ROBINSON TRACT RESIDENTIAL DEVELOPMENT STREET ROAD (S.R. 0926) AND NEW STREET CHESTER COUNTY WESTTOWN & THORNBURY TOWNSHIPS

May 15, 2020

RE: Robinson Tract Residential Development Westtown Township, Chester County, PA McMahon Project No. 816451.11

McMahon Associates, Inc. is in receipt of the Township's comment letter, prepared by Albert Federico Consulting, LLC in their capacity as the Township traffic engineer, dated March 13, 2020, in regards to the Transportation Impact Study for the Robinson Tract, prepared by our office and last revised December 2, 2019. It is noted that the applicant was not sent a copy of this letter for review. The development is proposed to be located on the Crebilly Farm property along the west side of U.S. Route 202 (Wilmington Pike), between West Pleasant Grove Road and Street Road (S.R. 0926), in Westtown Township, Chester County, Pennsylvania. On behalf of the applicant, below is a summary of the comments in italics, with our responses following each comment.

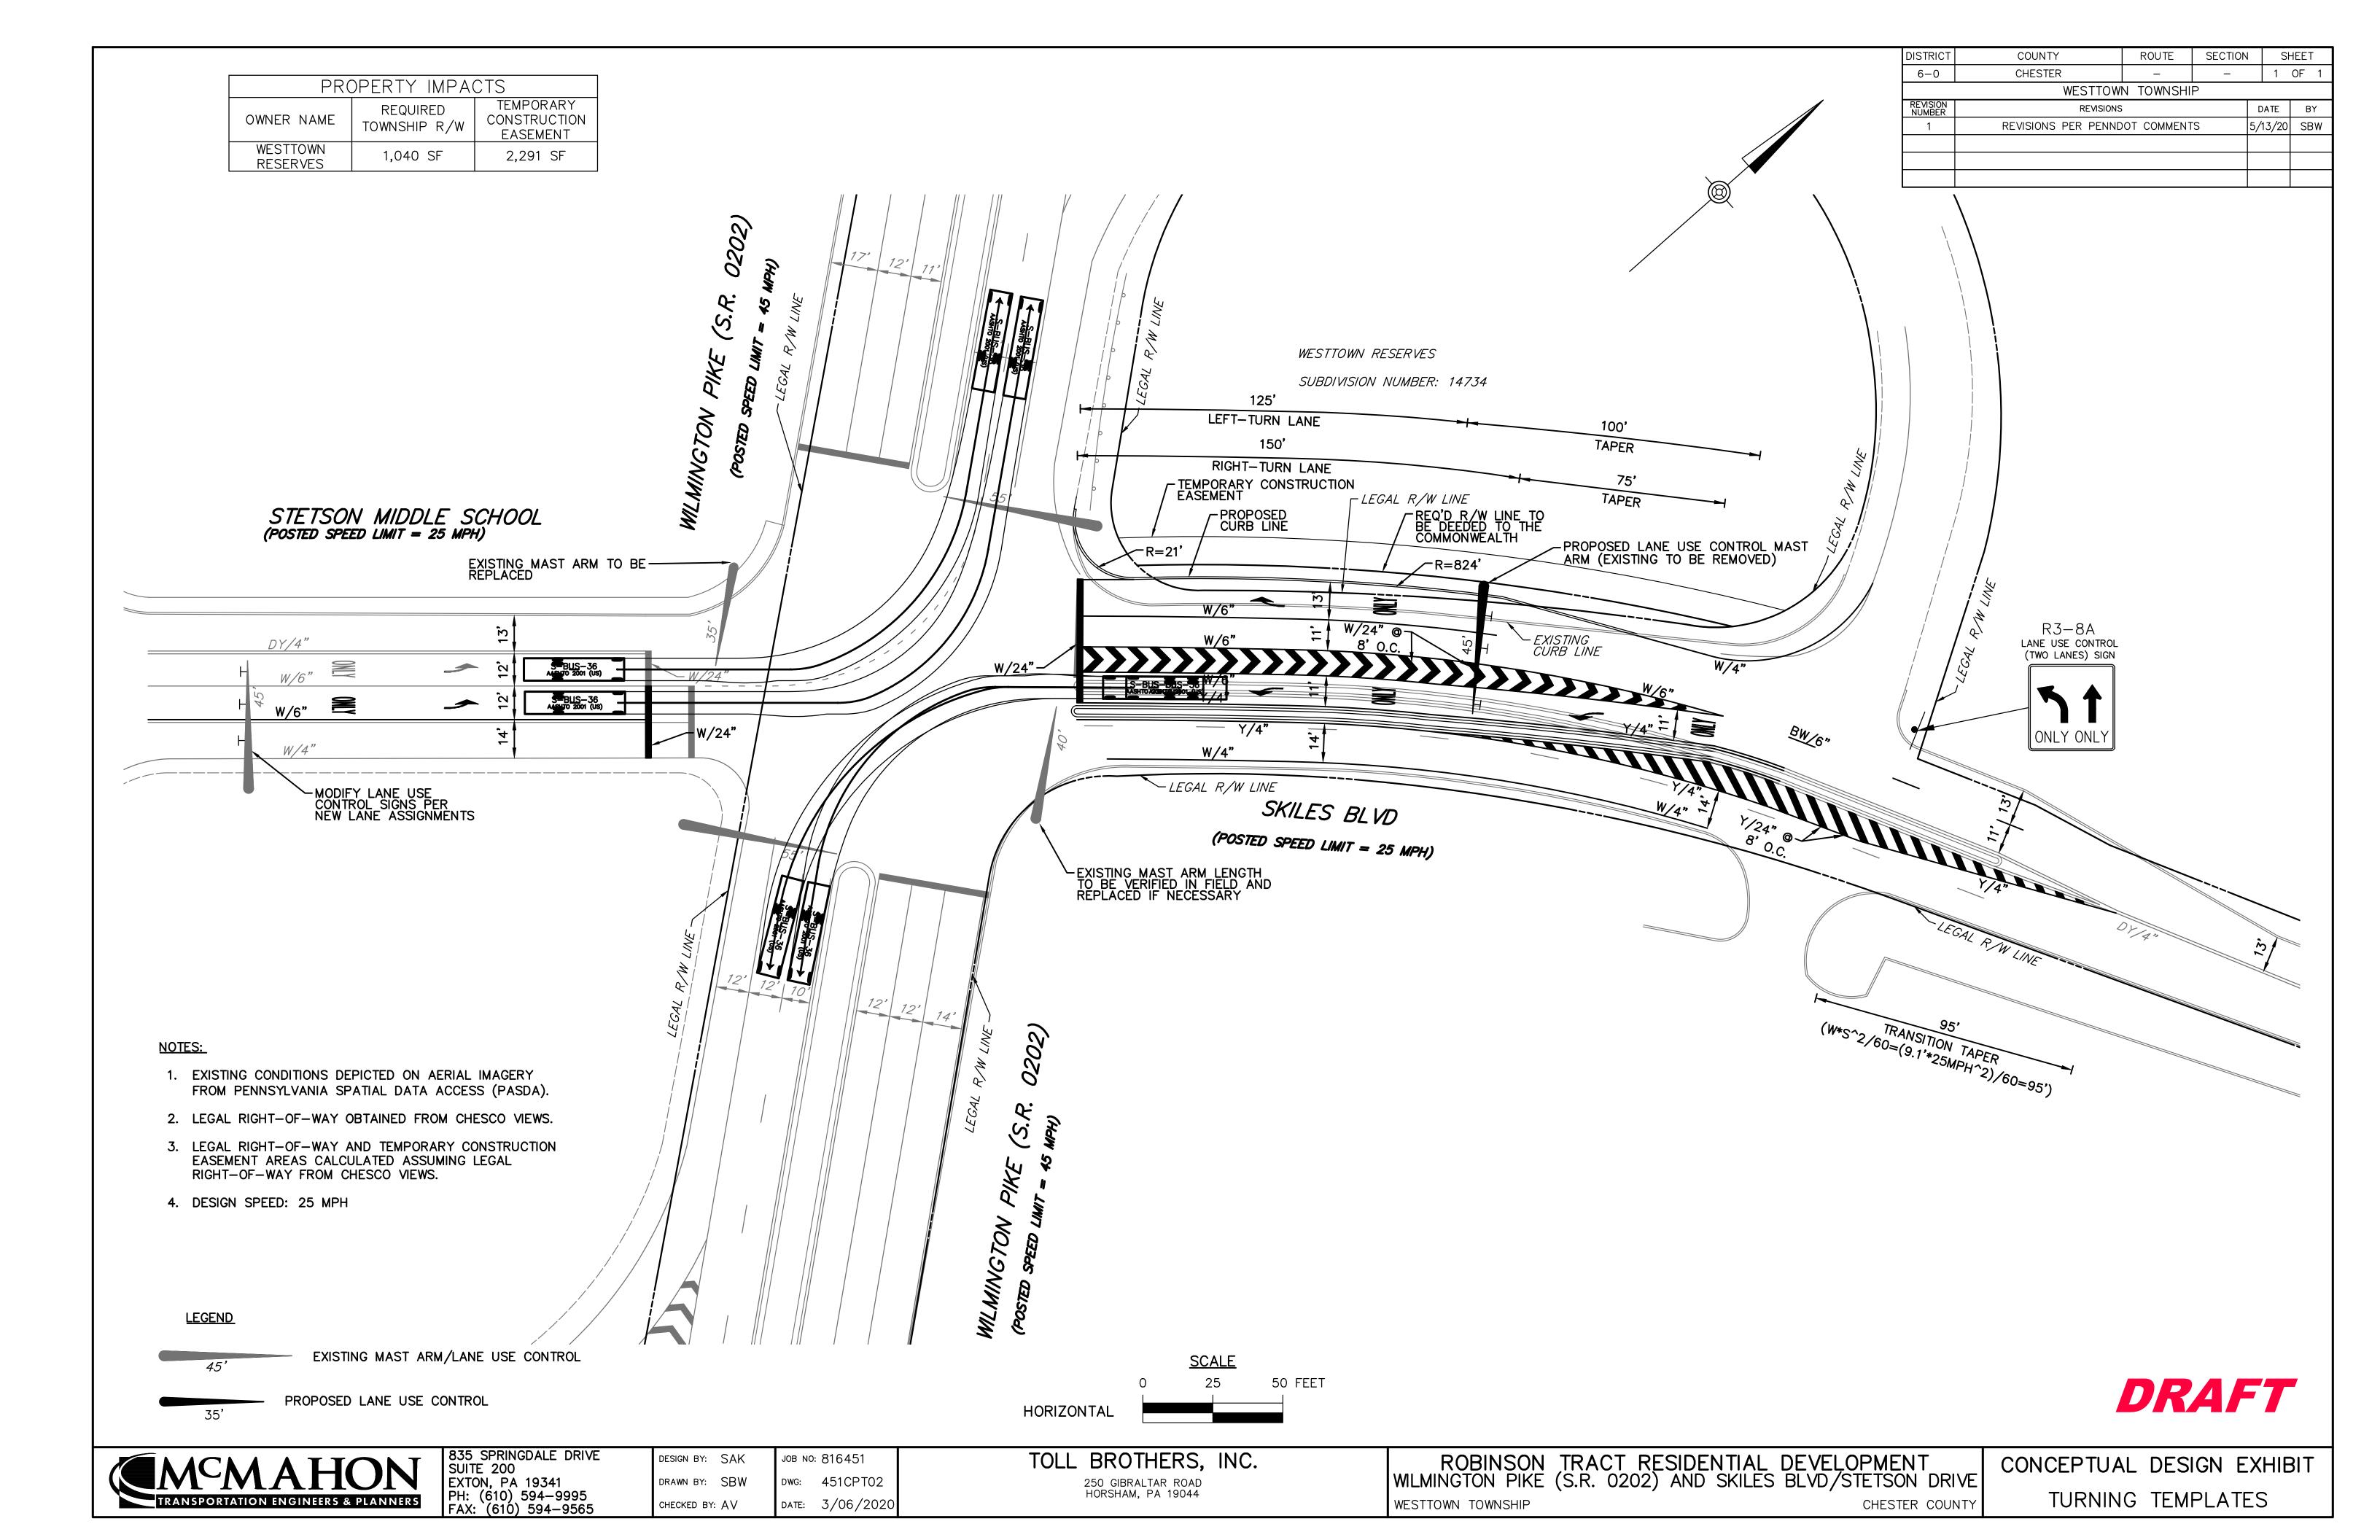
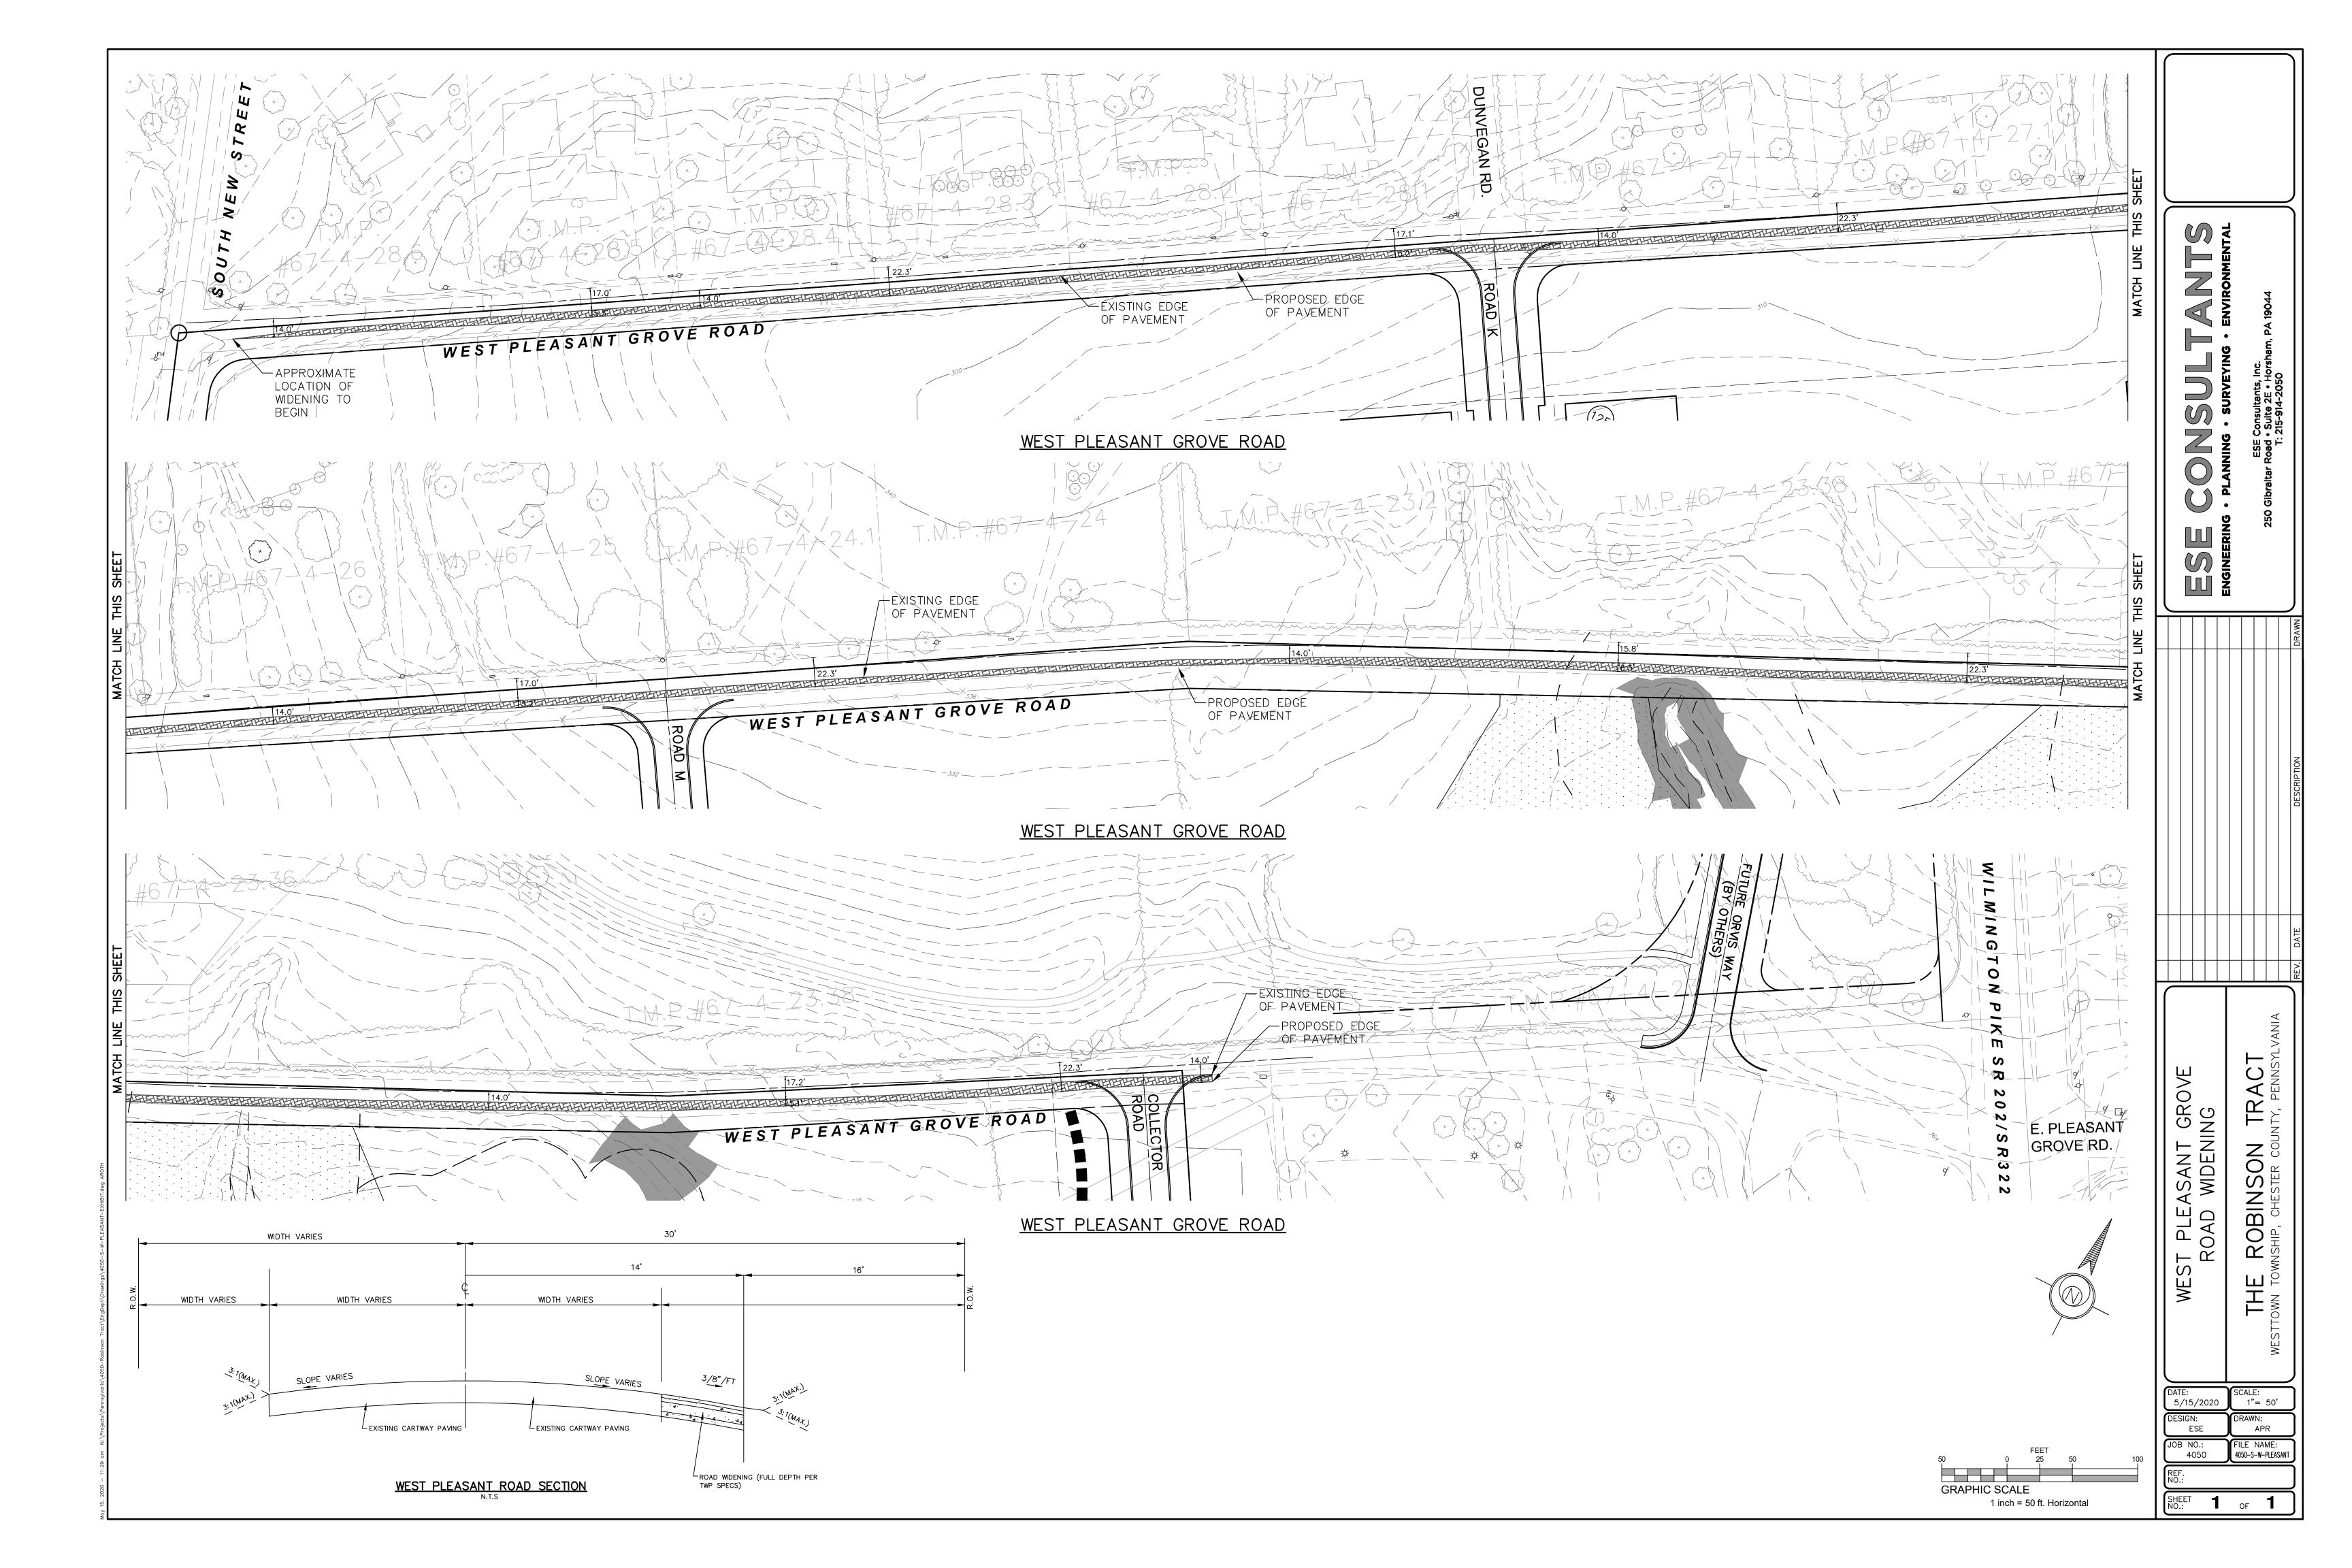
Additional grading and/or traffic management measures appear warranted to enhance safety at the three accesses proposed to have insufficient sight distance or the exact minimum distance (with no margin for error):

- (1) Collector Road at PA Route 926 (grading)
- (2) Road M at West Pleasant Grove Road (grading and/or roundabout)
- (3) Collector Road at West Pleasant Grove Road (grading and/or roundabout)

As documented on page 11 of the transportation impact study, dated revised May 15, 2020, the existing available sight distances at the site accesses meet or exceed the Township and PennDOT requirements. For the intersection of West Pleasant Grove Road and the Connector Road, the transportation impact study demonstrates that this intersection satisfies industry standard PennDOT traffic operations criteria and safety with stop-control on Collector Road approach. Aesthetics are not required by code. However, the applicant offers to install a mini roundabout at the Collector Road/West Pleasant Grove Road intersection, provided the Township acquires any necessary right-of-way to install. Traffic analysis worksheets for a mini roundabout at this location are attached.
